DA Application – Accessibility Assessment

**Bennetts Green Retail Development
Pacific Highway,
Bennetts Green NSW 2290**

Prepared by:	Ray Franke
Prepared for:	Blueprint Australia
Job No.:	74664
Date:	8 th November 2017
Revision:	-

McKenzie Group Consulting Job No: 74664
DDA Comments - DA Date: 6'th Nov 2017

SECTION 96 (2) APPLICATION - DA 251/2013
SITE PLAN

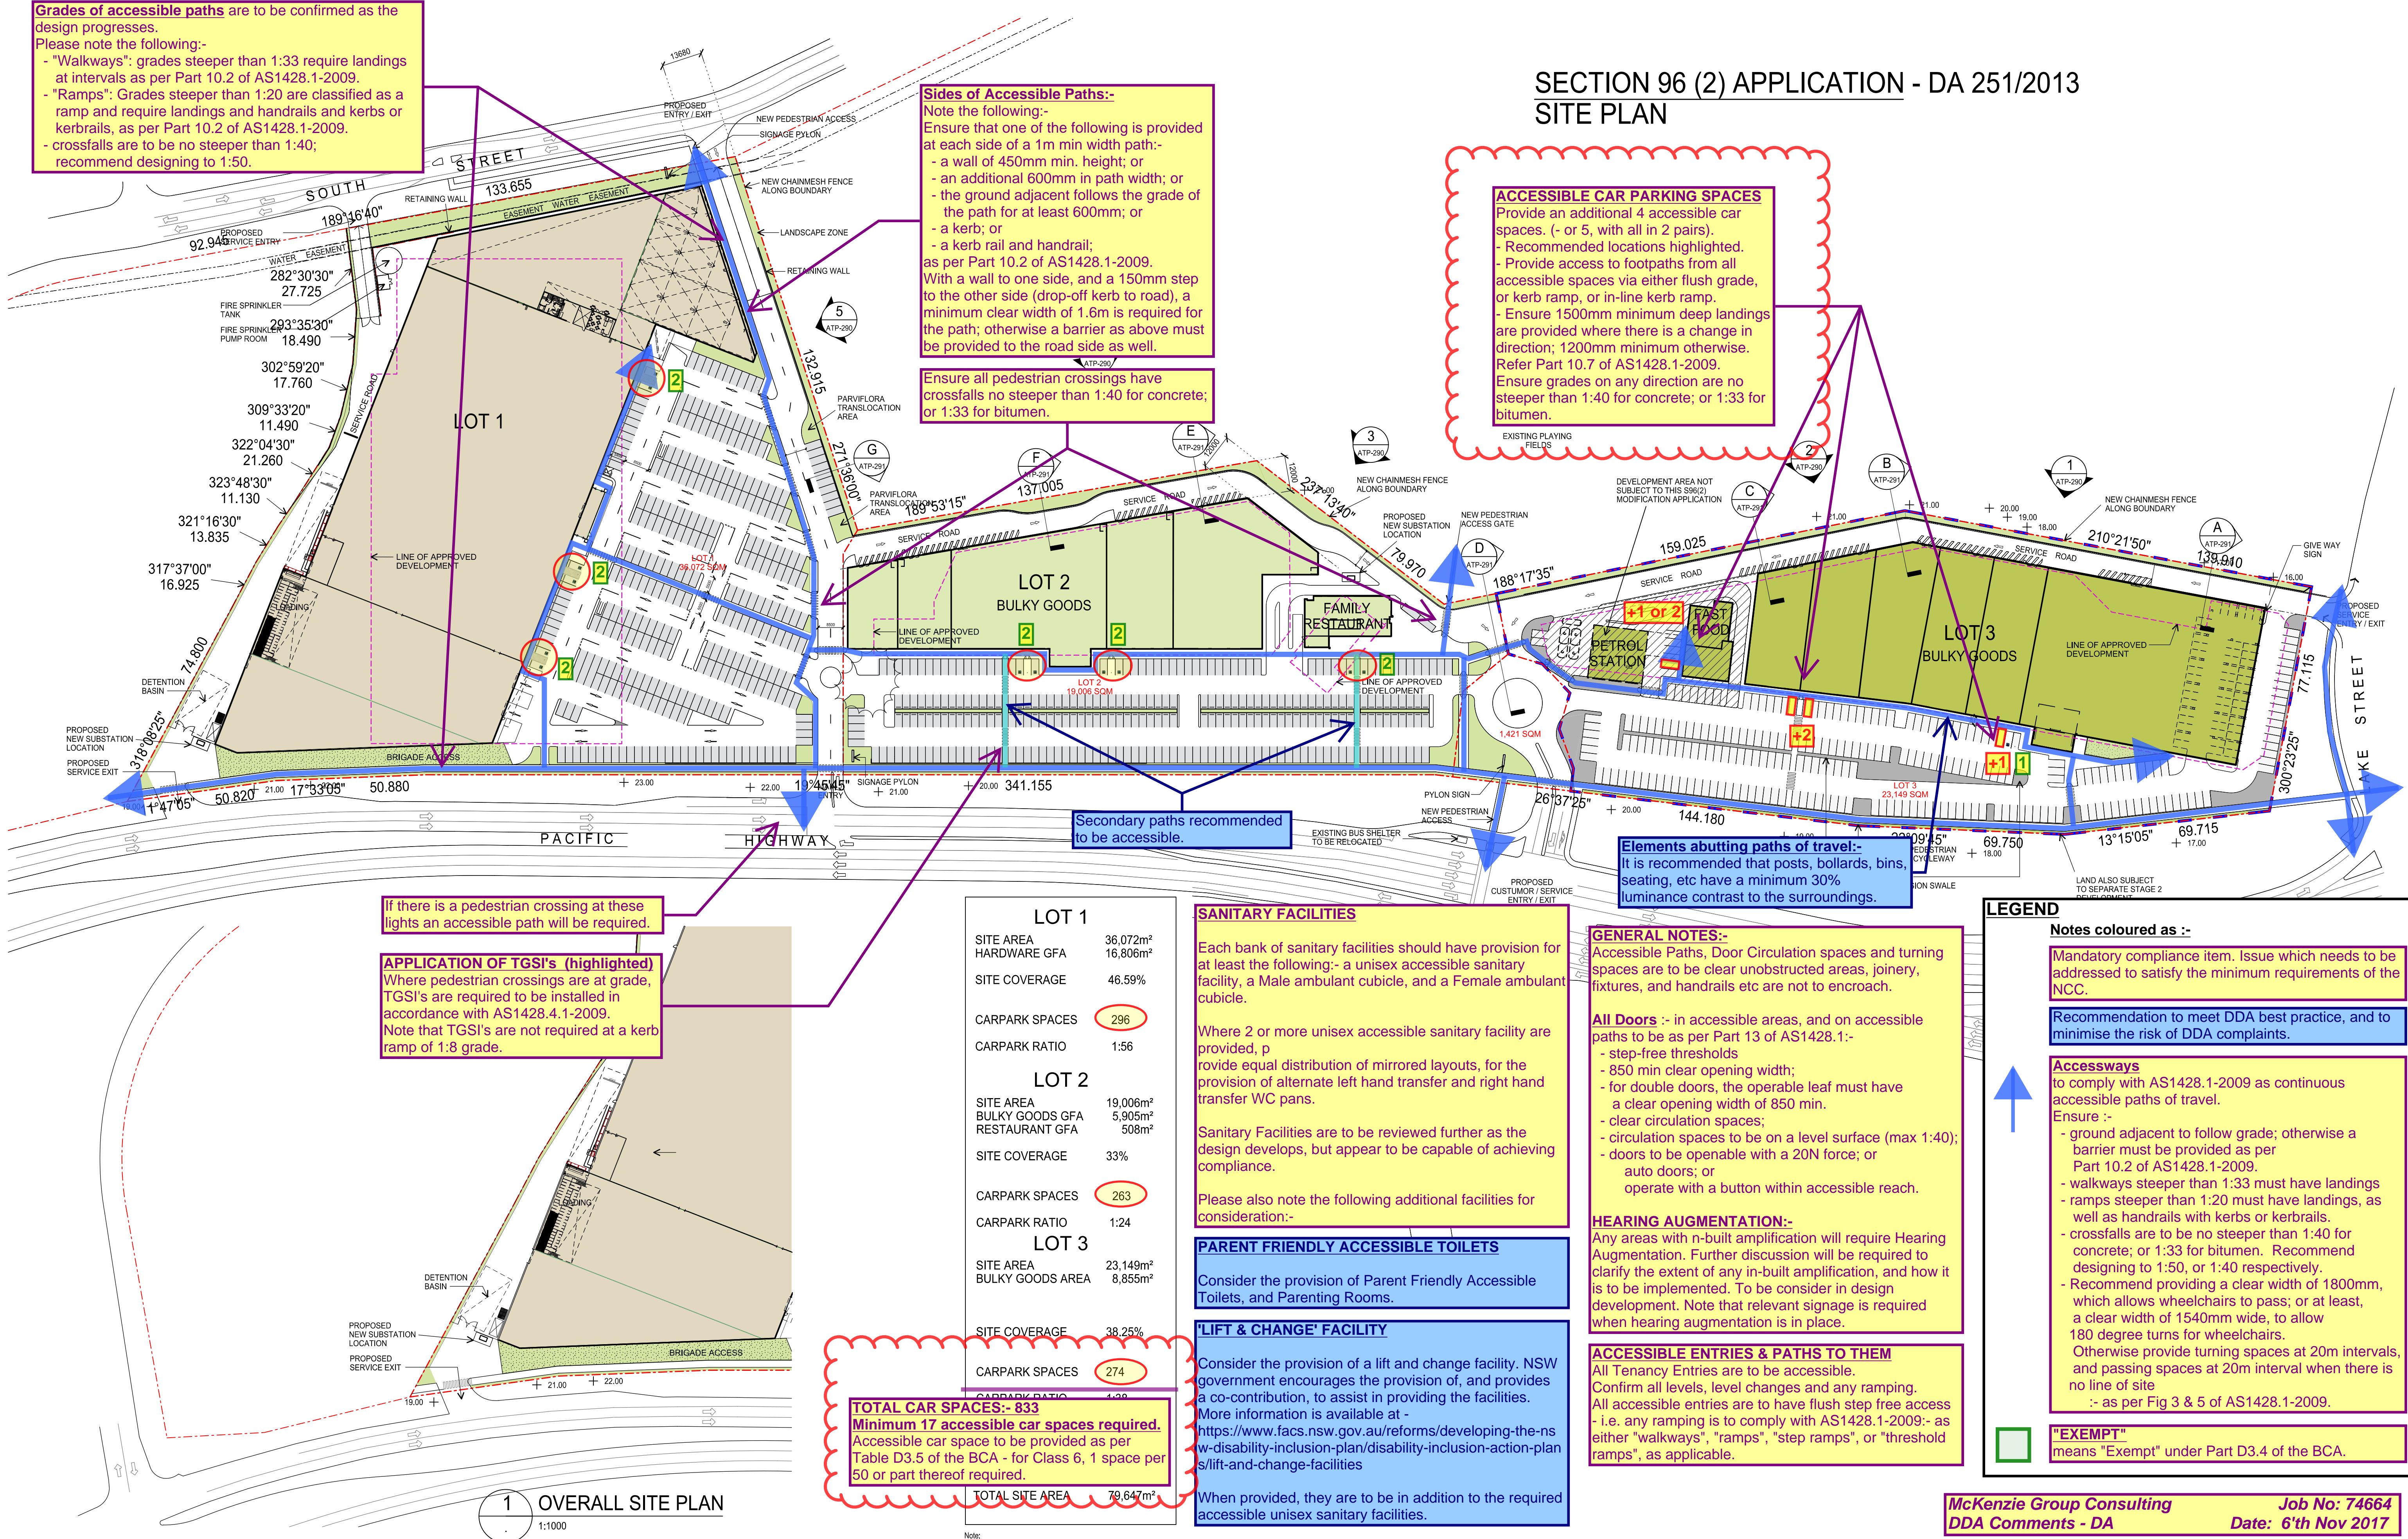
Grades of accessible paths are to be confirmed as the design progresses.
Please note the following:-
- "Walkways": grades steeper than 1:33 require landings at intervals as per Part 10.2 of AS1428.1-2009.
- "Ramps": Grades steeper than 1:20 are classified as a ramp and require landings and handrails and kerbs or kerbrails, as per Part 10.2 of AS1428.1-2009.
- crossfalls are to be no steeper than 1:40; recommend designing to 1:50.

Sides of Accessible Paths:-
Note the following:-
Ensure that one of the following is provided at each side of a 1m min width path:-
- a wall of 450mm min. height; or
- an additional 600mm in path width; or
- the ground adjacent follows the grade of the path for at least 600mm; or
- a kerb; or
- a kerb rail and handrail;
as per Part 10.2 of AS1428.1-2009.
With a wall to one side, and a 150mm step to the other side (drop-off kerb to road), a minimum clear width of 1.6m is required for the path; otherwise a barrier as above must be provided to the road side as well.

Ensure all pedestrian crossings have crossfalls no steeper than 1:40 for concrete; or 1:33 for bitumen.

ACCESSIBLE CAR PARKING SPACES
Provide an additional 4 accessible car spaces. (- or 5, with all in 2 pairs).
- Recommended locations highlighted.
- Provide access to footpaths from all accessible spaces via either flush grade, or kerb ramp, or in-line kerb ramp.
- Ensure 1500mm minimum deep landings are provided where there is a change in direction; 1200mm minimum otherwise.
Refer Part 10.7 of AS1428.1-2009.
Ensure grades on any direction are no steeper than 1:40 for concrete; or 1:33 for bitumen.

If there is a pedestrian crossing at these lights an accessible path will be required.

APPLICATION OF TGSi's (highlighted)
Where pedestrian crossings are at grade, TGSi's are required to be installed in accordance with AS1428.4.1-2009. Note that TGSi's are not required at a kerb ramp of 1:8 grade.

Secondary paths recommended to be accessible.

Elements abutting paths of travel:-
It is recommended that posts, bollards, bins, seating, etc have a minimum 30% luminance contrast to the surroundings.

TOTAL CAR SPACES:- 833
Minimum 17 accessible car spaces required.
Accessible car space to be provided as per Table D3.5 of the BCA - for Class 6, 1 space per 50 or part thereof required.

SANITARY FACILITIES
Each bank of sanitary facilities should have provision for at least the following:- a unisex accessible sanitary facility, a Male ambulant cubicle, and a Female ambulant cubicle.
Where 2 or more unisex accessible sanitary facility are provided, provide equal distribution of mirrored layouts, for the provision of alternate left hand transfer and right hand transfer WC pans.
Sanitary Facilities are to be reviewed further as the design develops, but appear to be capable of achieving compliance.
Please also note the following additional facilities for consideration:-
